CHANNING COURT SUBDIVISION

Engineering Comments: FINAL PLAT COMMENTS (should be addressed prior to submitting the FINAL PLAT for review and/or signature by the City Engineer):

APPLICATION NUMBER 6 DATE March 21, 2019

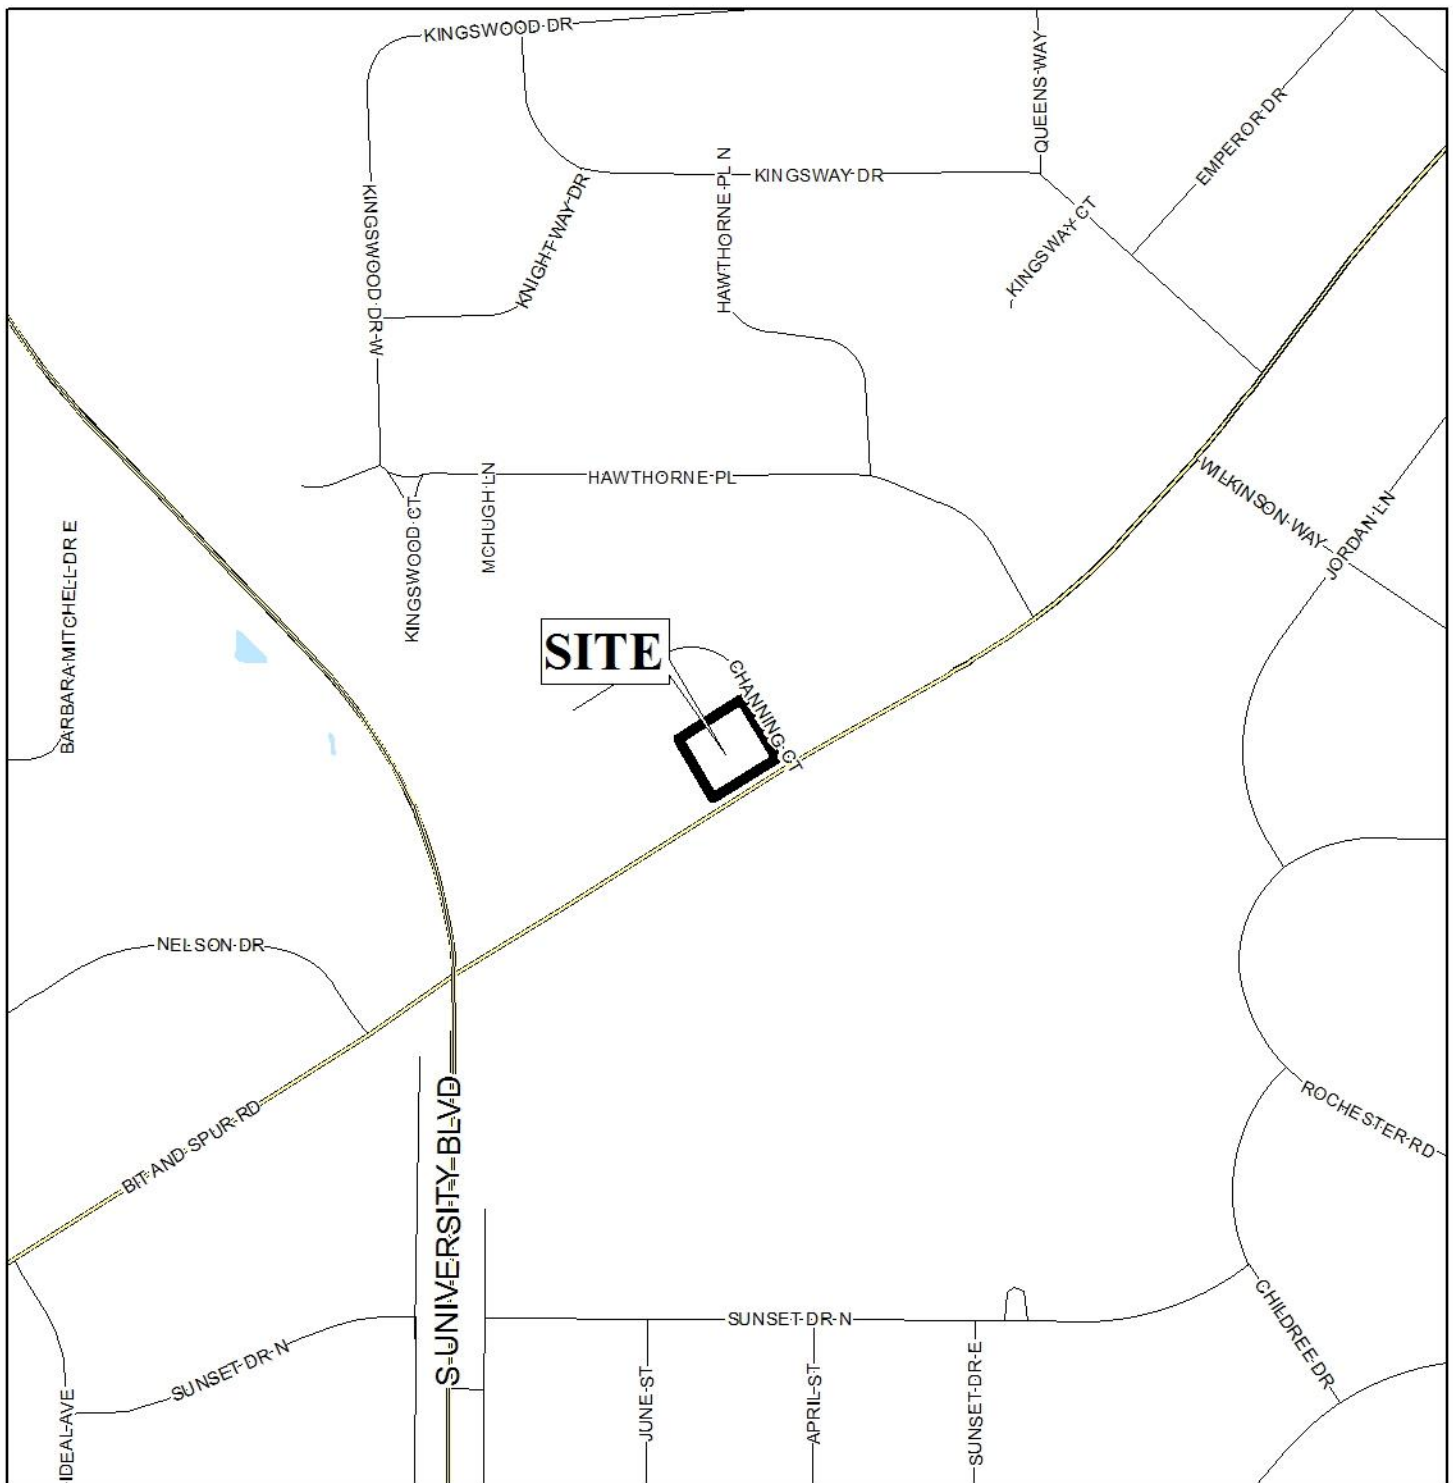
The preliminary plat depicts the 25' minimum building setback line for Lot 1 and Lot 2 along Channing Court; however the plat only depicts a 20' minimum building setback line along Bit and Spur Road for Lot 1. It should be pointed out that Section V.D.9. of the Subdivision Regulations requires the provision of a 25' minimum building setback from the "front property lines". However, the Zoning Ordinance would allow the Bit and Spur Road frontage to be considered a side street thus allowing the 20' setback line; therefore a waiver of V.D.9 may be appropriate.

Based on the preceding, and with a waiver of V.D.9, this application is recommended for Tentative Approval subject to the following conditions:

- 1) retention of the 25' minimum building setback line along Channing Court;
- 2) retention of the 20' minimum building setback line along Bit and Spur Road;
